**Wilsonville City Hall
Development Review Board Panel A**

Monday, September 11, 2017 - 6:30 P.M.

B. Resolution No. 342

Exhibit A1
Planning Division Staff Report
Hilton Garden Inn

1 ENLARGED PLAN - TRASH ENCLOSURE
SCALE: 1/4" = 1'-0"

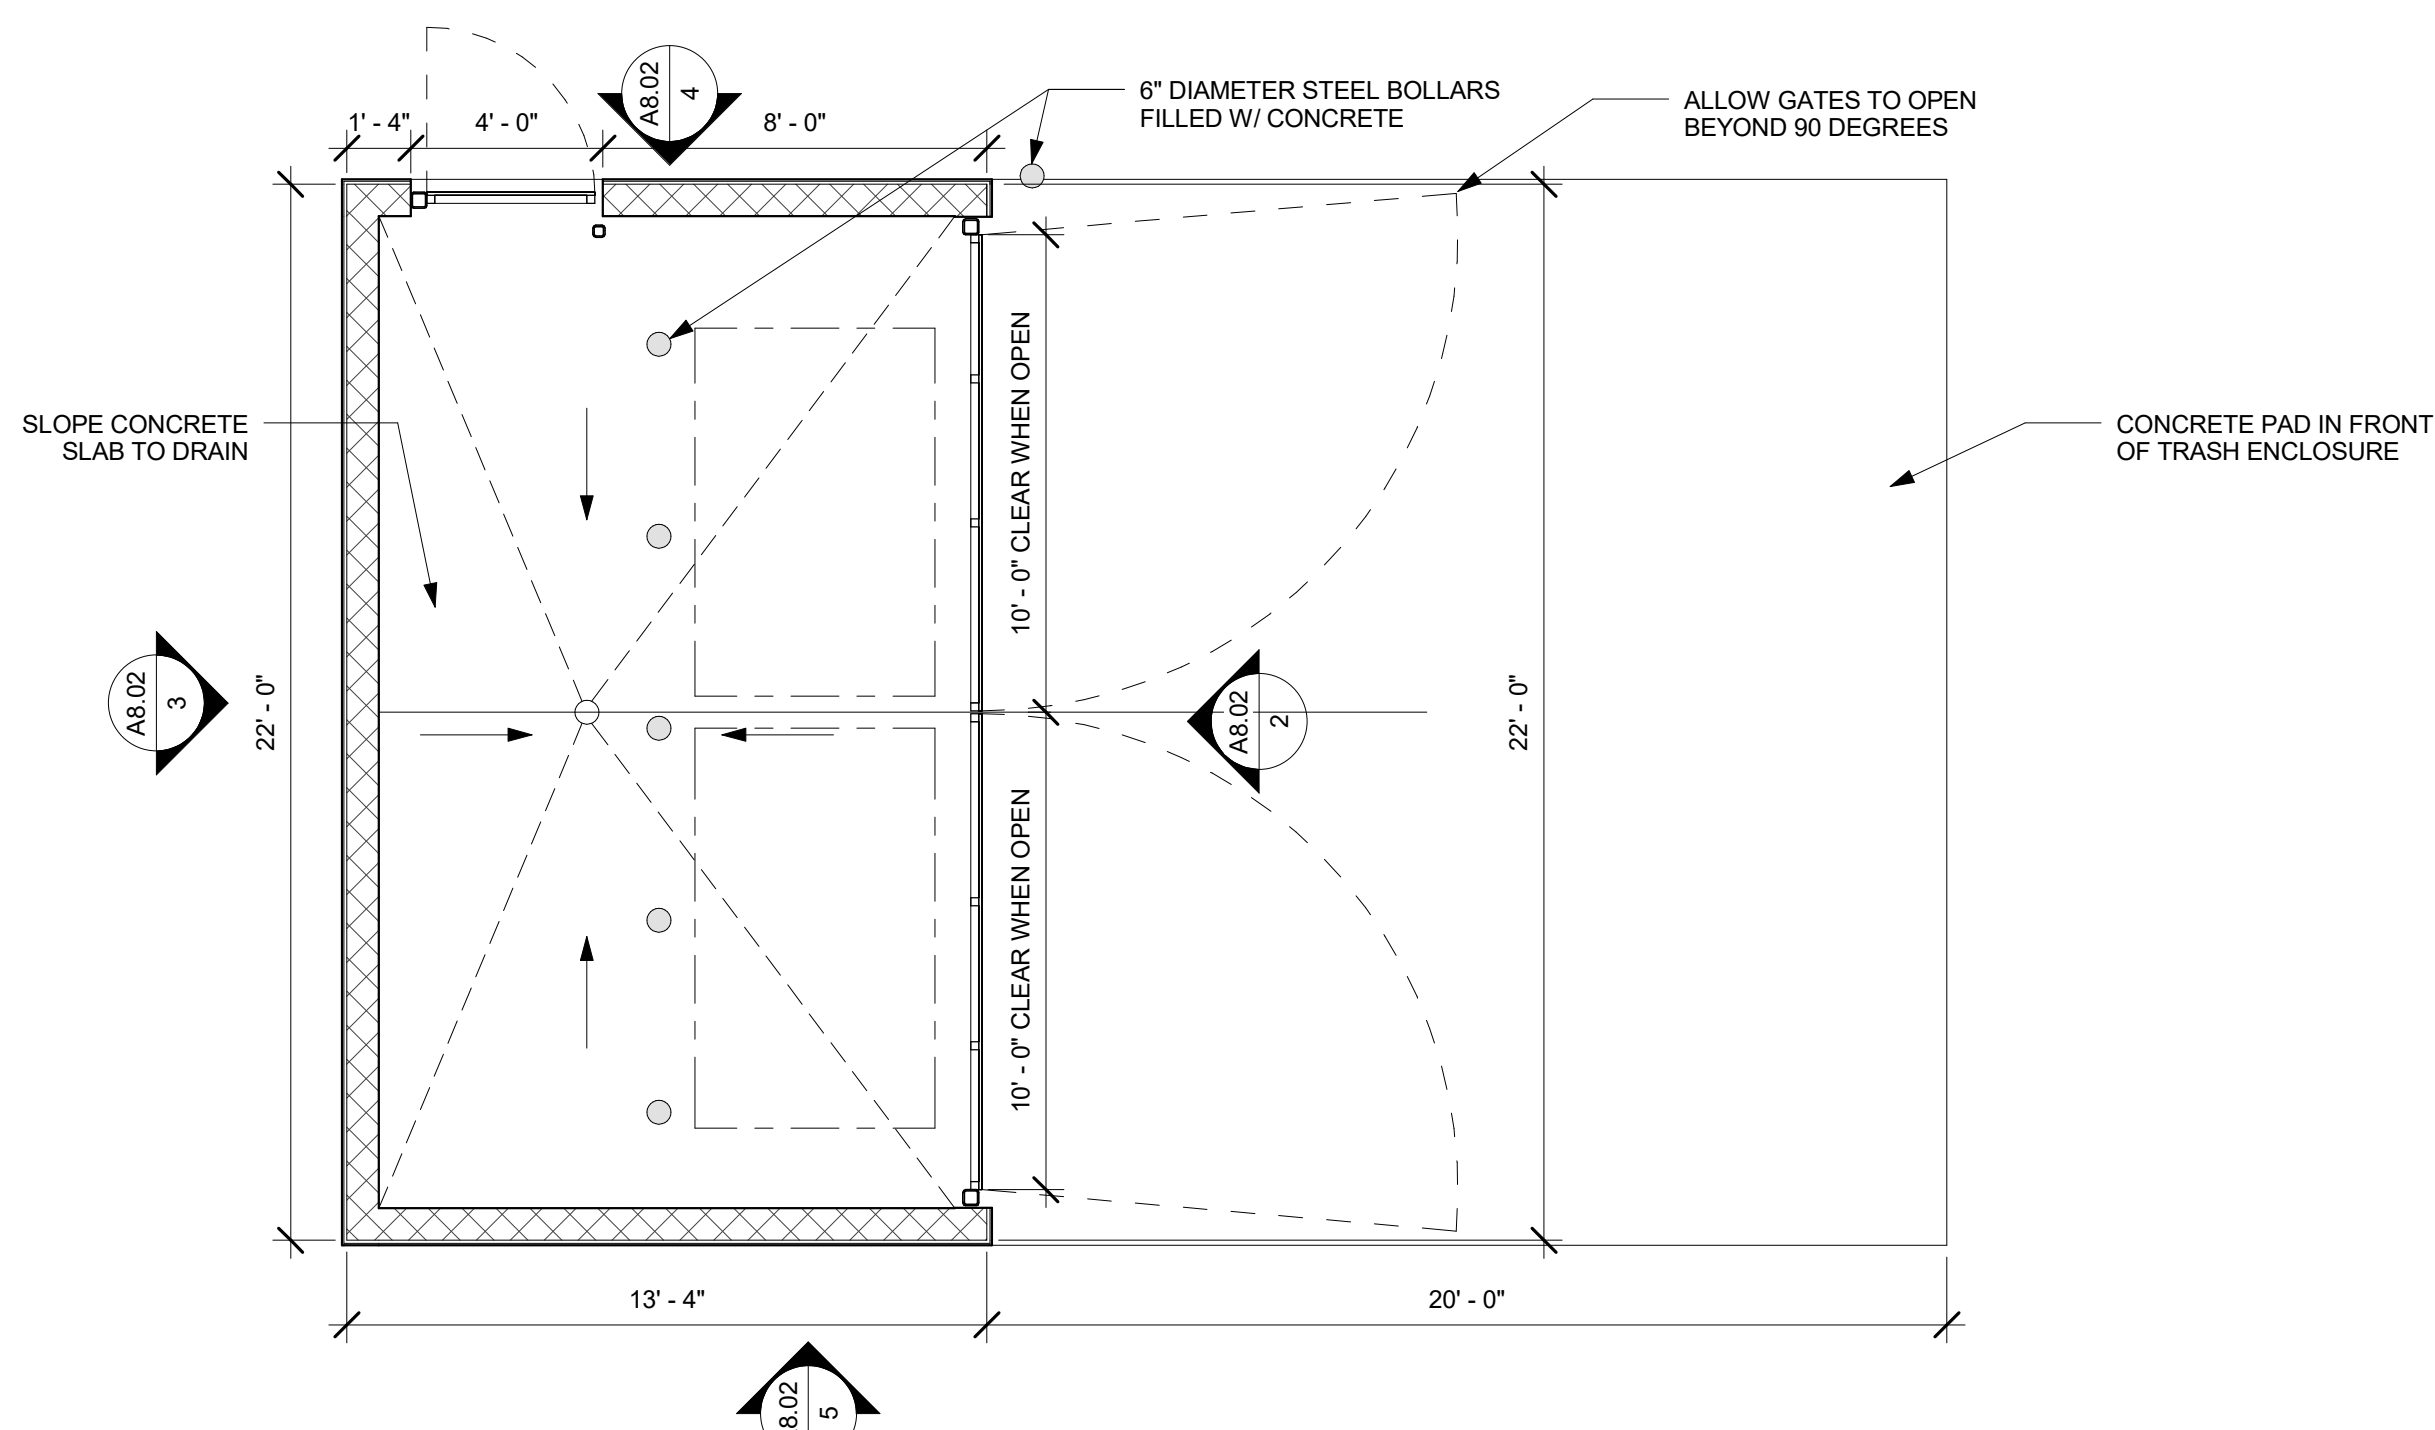
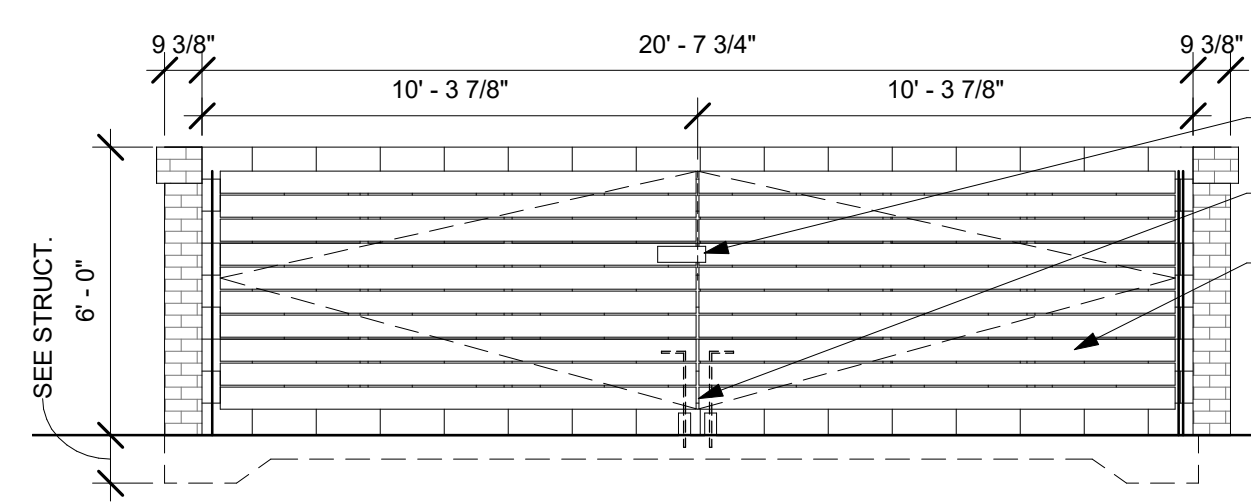
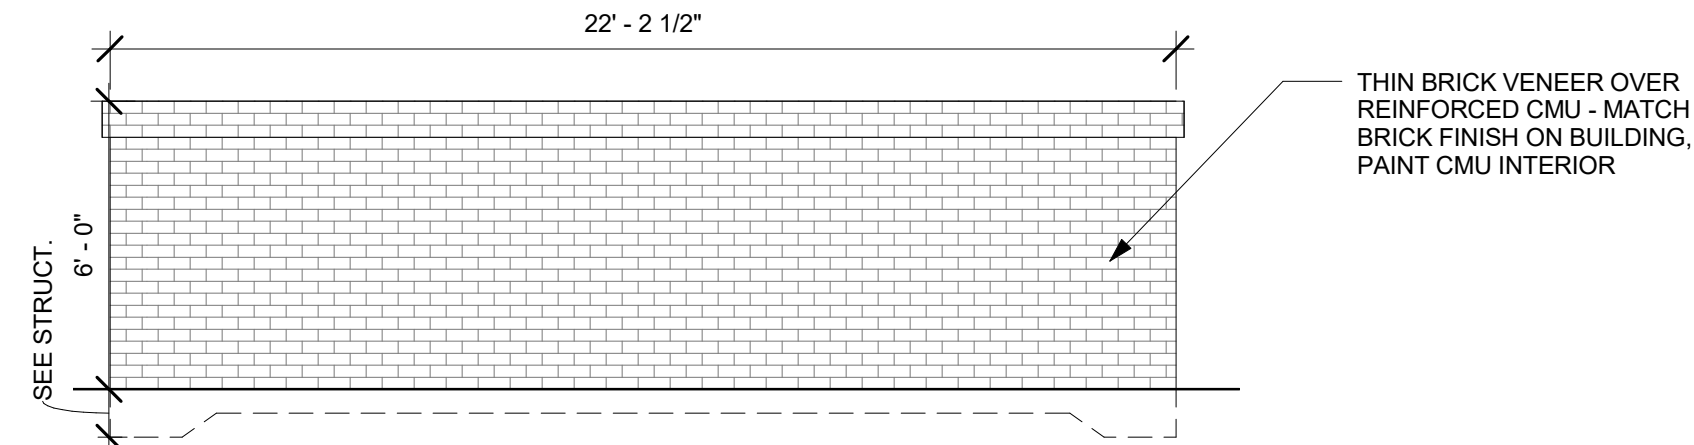
Response: Sheet A8.02 of Exhibit B23 shows an enclosure meeting all the standards listed in this Section. The enclosure has also been approved by the franchise solid waste hauler. See Exhibit B2.
